Bill No. 07R-20

TITLE: **SPECIAL PERMIT NO. 872F,** requested by Firethorn Investment, for authority to expand the boundaries of the **Firethorn Community Unit Plan** and to add 95 single family residential lots, on property generally located northeast of the intersection of South 84th Street and Pioneers Boulevard.

PROJECT #: Special Permit #872F for Firethorn Community Unit Plan (CUP).

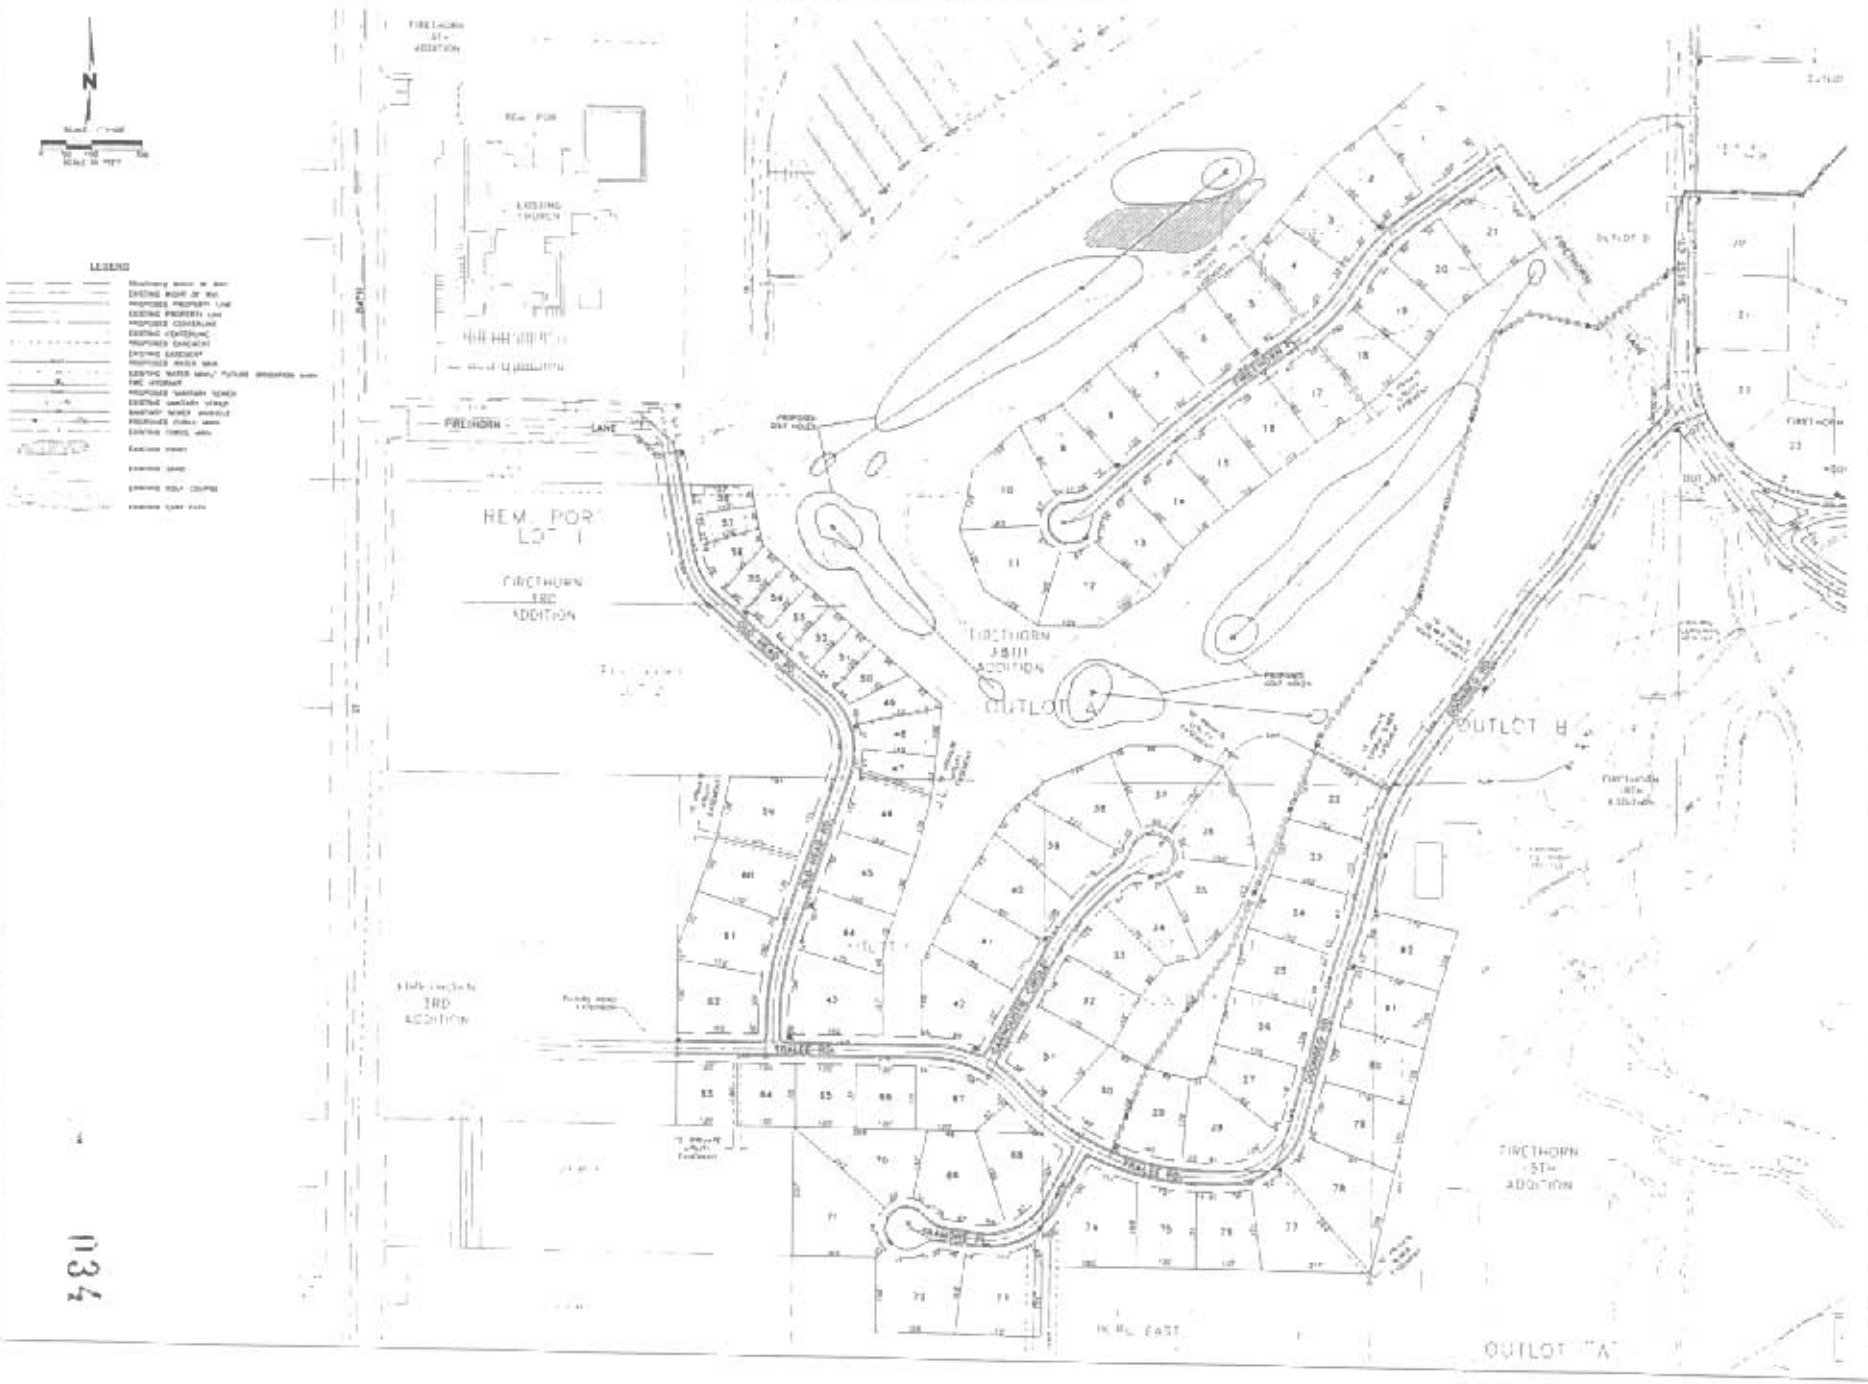
3.1.1 A revised site plan including 5 copies showing the following revisions:

3.1.1.1 Revise the Proposed/Existing Lots table to note the total number of acres of land in the CUP.

3.1.1.2 Revise General Note #4 to state: THIS CUP ALLOWS 545 DWELLING UNITS AND ONE CLUBHOUSE FACILITY.

3.1.1.3 Show ~~the~~ a street connection to ~~South 88th Street~~ Pioneers Boulevard. **(**Per Planning Commission: 12/20/06**)**

3.1.1.4 Revise General Note #1 from 'Special Permit #872' to 'Special Permit #872E'.

3.1.1.5 Delete General Notes #11 and #15.

3.1.1.6 Revise General Note #14 to state: ALL SIDEWALKS, DRIVEWAYS AND PARKING LOTS TO BE PAVED TO CITY OF LINCOLN DESIGN STANDARDS.

3.1.1.7 Revise General Note #19 to state: SIGNS NEED NOT BE SHOWN ON THE SITE PLAN AND THE LOCATION AND SIZE WILL BE APPROVED AT THE TIME OF SIGN PERMITS IN COMPLIANCE WITH THE ZONING ORDINANCE.

3.1.1.8 Revise General Note #24 to specify where the common access over drives and parking stall is granted.

3.1.1.9 Revise General Note #29 to state: THE SALE OF ALCOHOLIC BEVERAGES FOR CONSUMPTION ON THE PREMISES IS PERMITTED PER LMC 27.63.680.

3.1.1.11 Revise General Note #33 to state: THE BUILDING ENVELOPES SHOWN ARE FOR ILLUSTRATING THE PERMITTED USES AND THEIR APPROXIMATE LOCATIONS. FINAL SITE LAYOUTS TO BE DETERMINED AT THE TIME OF BUILDING PERMITS.

3.1.1.12 Revise General Note #34 to state: REQUIRED EASEMENTS TO BE DETERMINED AT THE TIME OF FINAL PLAT.

3.1.1.13 General Note #35 conflicts with General Notes #14 and #15. Either revise or delete General Note #35.

3.1.1.14 General Notes #16 and #36 conflict. Revise to specify actual road standard and eliminate conflict between the notes.

3.1.1.17 Show a public sanitary sewer easement in a location acceptable to Public Works and Utilities.
